URGENT MEDICAL DEVICE CORRECTION

Affected Product: ROSA Brain 3.0 and/or ROSA One 3.1 Brain application

ROSA Brain 3.0 and ROSA One Application-Brain

Examples of Reconstruction and Display Issues

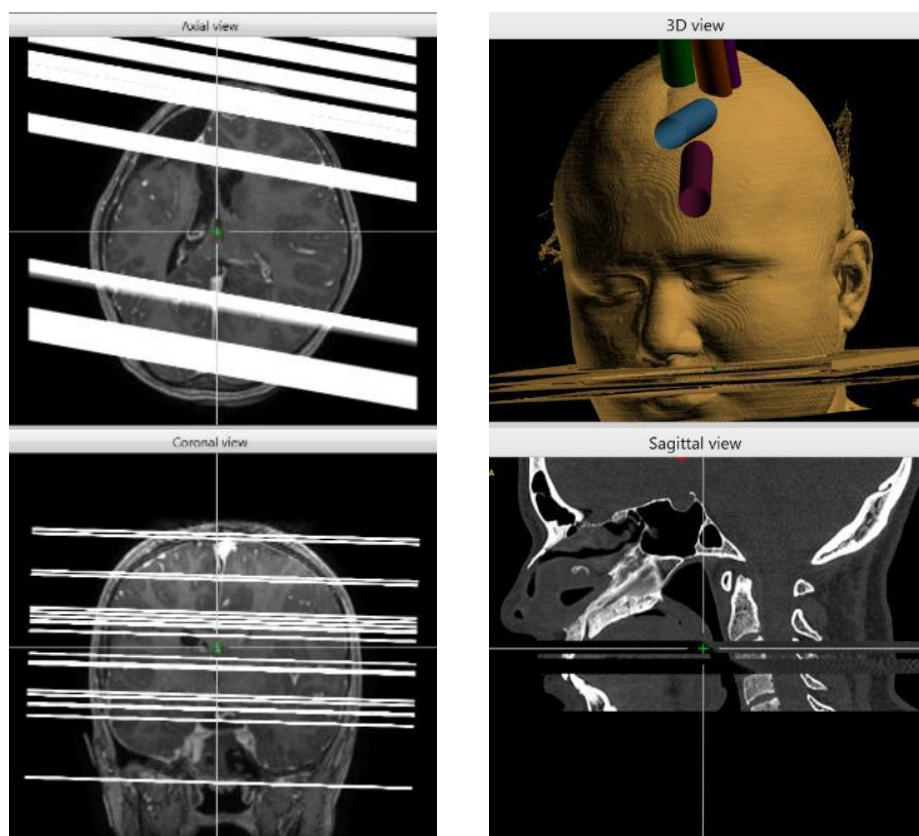
Zimmer Biomet is aware of events where some cross-sectional images from the image acquisitions of the patient's head are not reconstructed/displayed properly in two and three dimension views when using ROSA Brain software, potentially compromising the surgery planning.

This issue has resulted in three medical device reports (MDRs) being reported and in all of these cases, there were artifacts found in the original CT/MRI scan. The data from the scans were not properly read by the ROSA Brain software and therefore led to incorrect image display and reconstruction. The issue is highly detectable by the user and affects only the information displayed to the user. There is no impact on the geometry / topology of the reconstruction, and consequently distances, trajectories and device accuracy are not affected. In all of the reported cases, this issue was discovered prior to surgery.

Examples of the issue are provided below:

Due to this potential image management issue, **Zimmer Biomet recommends that images be reviewed using the ROSA Brain software prior to surgery.** If an issue is detected with the reconstruction and display of the images using the ROSA software, and if the artifacts are located in the Region Of Interest and prevent the surgical planning, then the surgery might have to be cancelled or converted to traditional surgery. However, if the artifacts are not located inside the Region Of Interest and if the surgery planning is successful, the affected device can continue to be used.
